City of Portland, Maine – Building or Use Permit Application 339 Congress Street, 04101, Tel: (207) 874-8703, FAX: 874-8716

Location of Construction: 192 Caleb St		Owner: Kirchner, Theodore & Diane		Phone:		Permit No: 980092
Owner Address: SAA Portland, ME 04102		Lessee/Buyer's Name:		Phone: 772-4700		
Contractor Name: Willow Ledge Builders		Address: P.O. Box 859 Yarmouth, ME 04096		Phone: 846-6944		Permit Issued: FEB 11 1998
Past Use: 1-iam		Proposed Use: Same		COST OF WORK: \$ 80,000.00 320.00 PERMIT FEE: \$ 320.00 320.00		
Proposed Project Description: Make Interior & Exterior Renovations				FIRE DEPT. <input type="checkbox"/> Approved <input type="checkbox"/> Denied Signature: _____ PEDESTRIAN ACTIVITIES DISTRICT (P.A.D.) Action: <input type="checkbox"/> Approved <input type="checkbox"/> Approved with Conditions <input type="checkbox"/> Denied Signature: _____ Date: _____		Zoning Appeal <input type="checkbox"/> Variance <input type="checkbox"/> Miscellaneous <input type="checkbox"/> Conditional Use <input type="checkbox"/> Interpretation <input type="checkbox"/> Approved <input type="checkbox"/> Denied Historic Preservation <input checked="" type="checkbox"/> Not in District o

Kirchner
192 Calab ST
Portland

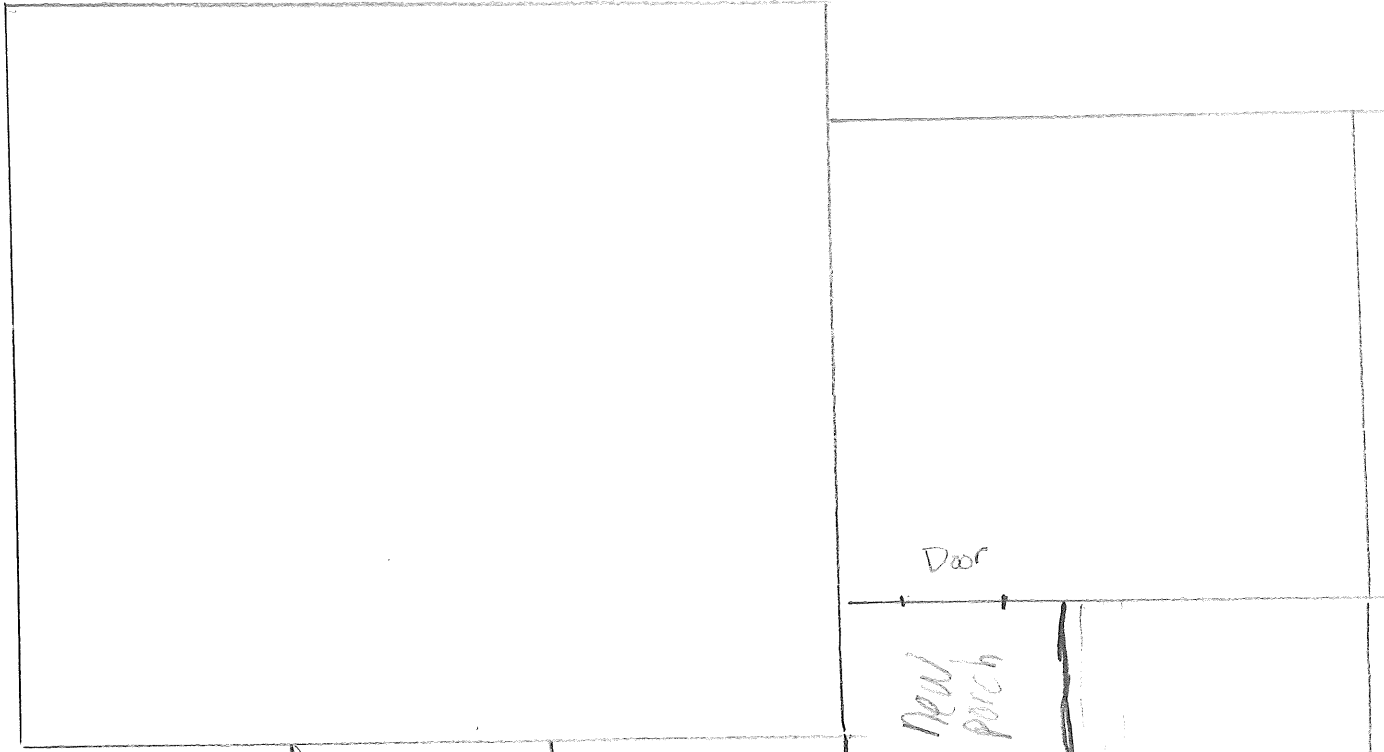
2-18-98 - Front set back is not marked by pins or line / snow ice covering area in question / told Mrs Kirchner I would not allow porch projection beyond leading edge of Main House / this Setback appears to be 25' / only with more evidence of position of Front property line or Survey Report / would I allow projection to be constructed also framing started in garage area

7. Separate permits shall be required for any signage.
8. Separate permits shall be required for future decks and/or garage.
9. Other requirements of condition The front setback to the new porch

shall be no less than 25 feet in measurement.

SECTION @ ENTRY HALL

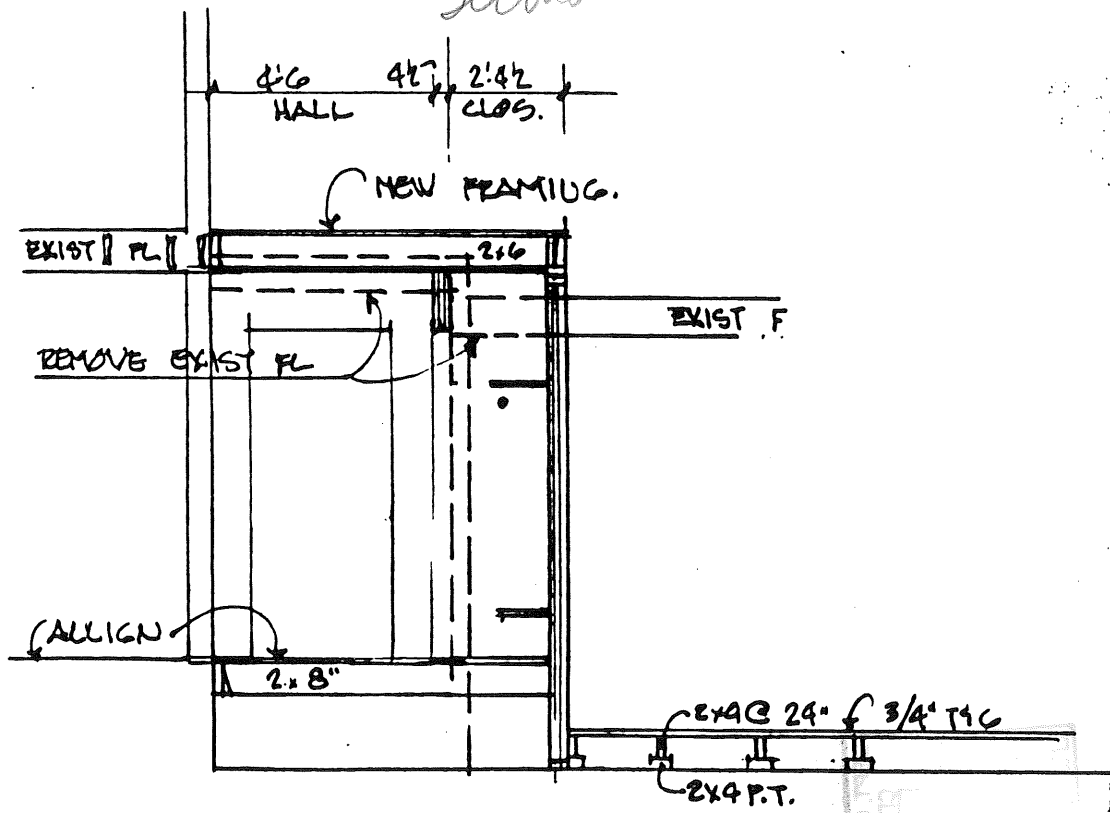
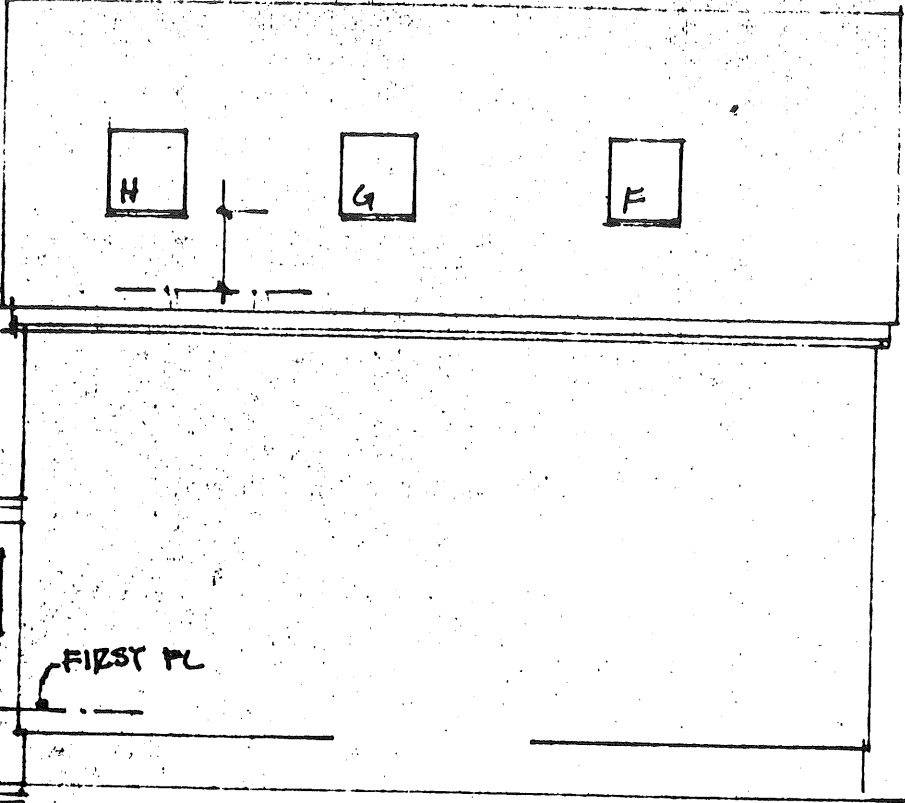
3/20/98 Framing inspection - need to see detail on framing at entry. have asked for details.

I was asked by the by the Contractor on this project, Mike Wilbur of Willow Ledge Construction to get some information to you regarding the strength of the hanger provided at the beam junction above the kitchen where we altered the structure. The work was done under my instructions and the beams and hangers were sized to take the required loads.

For the joint in question, the design load was about 3,000 pounds. The hanger chosen to carry the connection, a Simpson Hanger # HGUS 5.56/10 is rated at 7,750#, well above the design load. This joint should not present any structural problems.
